**Alachua County  
Board of County Commissioners  
Staff Report**

**Project Number: DR23-000022**

**Final Redevelopment Plan for Chevron at Newberry and Tower Road**

**DESCRIPTION:** Redevelopment of gas station (fuel sales) site with same use

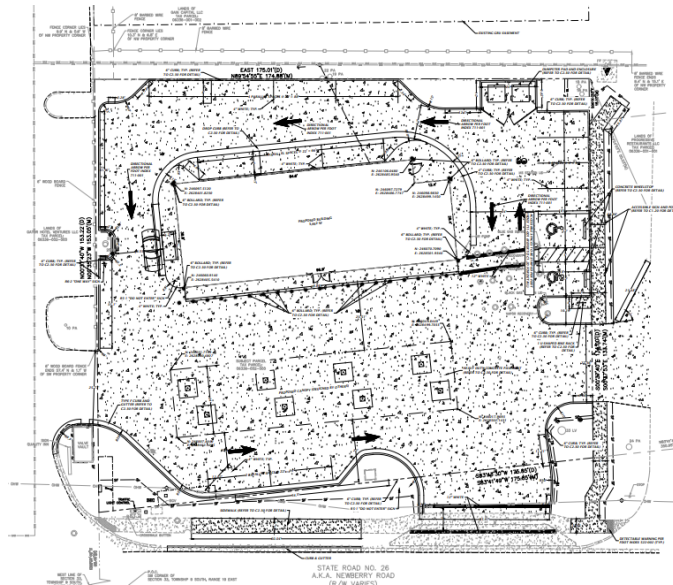
*While Activity Center standards require buildings pulled to the street, this cannot be achieved on this parcel while maintaining the business owner's merchantability. This application originated with the property owner's desire to reinvest in the site, renovate the building and canopy structure, and provide a safer operational condition and add the Card-Lock fueling services for our community's First Responders...The owner's desire to retain the active business and provide a much more usable fuel and retail store, very similar to the recent Chevron station's redevelopment on the other side of the I-75 interchange...*

*A deviation is requested because placement of the building near the Newberry*

*Road property line to 'give definition to the street scape, individual block, and the perimeter of the site', prevents fuel tanker trucks from entering the site.*

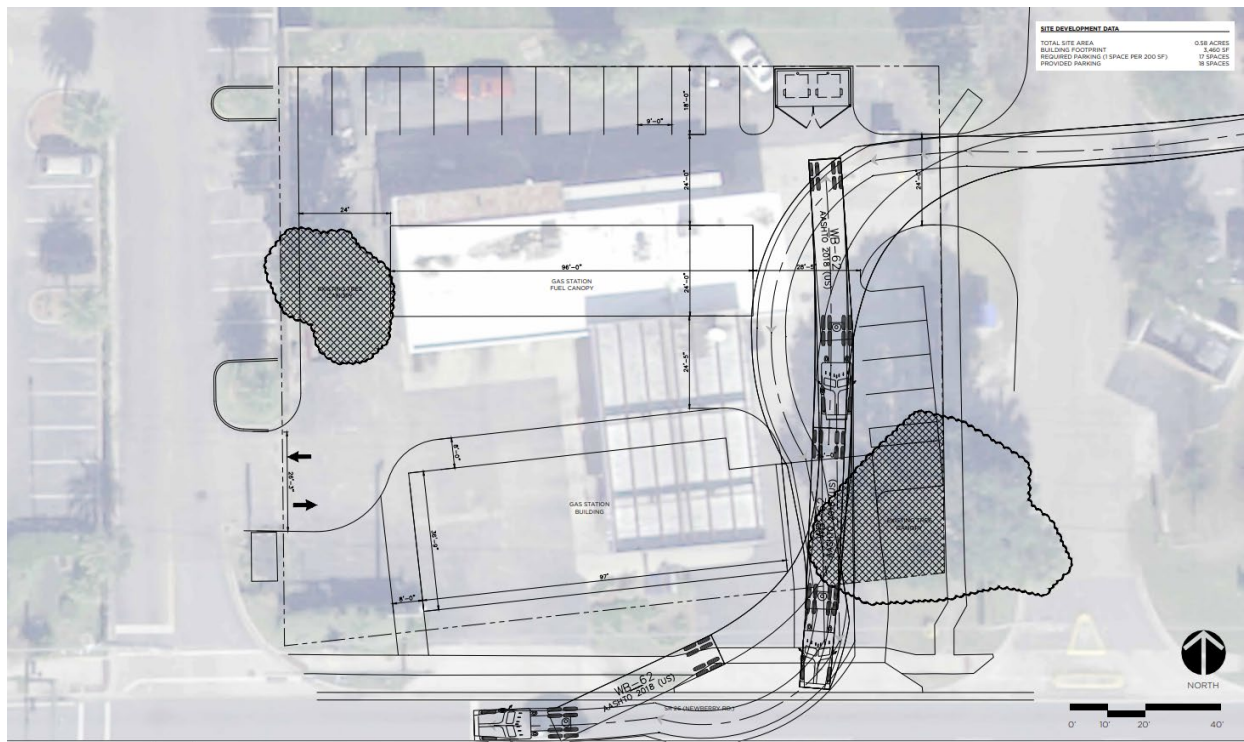
**Staff analysis:** The BoCC must find the deviation to be the minimal possible. Staff cannot recommend that the deviation is the minimal possible when the proposal maintains a nonconforming layout in an Activity Center.

The proposed Final Redevelopment Plan, which is shown below, provides the new building to the north of the canopy.

The applicant's contention is that that the site's main challenge is the small parcel size (0.57 acre) and its functional driveway connections to the west, south and east which they state limits the fuel delivery trucks to using existing driveways on the property. The applicant did work through other layout options for the site, but they resulted in auto-turn conflicts with fuel delivery trucks (see Activity Center Justification July 31, 2023 letter). The image below is from this justification report. It shows the building moved up to the street with the parking and gas canopy to the north. Auto turn movements show a clipping of the gas canopy.

The development plan shows an additional 15 parking spaces are provided. The majority of these are code compliant and to the side and rear of the building. However, two parallel spaces are provided south of the fuel canopy. **The location of these spaces are not consistent with Sec. 405.07(c)(4)a.**

Due to the building location, it is impossible for pedestrians to not have to cross a drive aisle to get to the building. The existing 5-foot-wide sidewalk along the eastern edge of the property is proposed to be reconstructed, but that entails pedestrians having to cross a drive aisle in two locations, both with two-way traffic.

If the two parallel spaces at the front of the site are removed, then the parking layout is still code compliant.
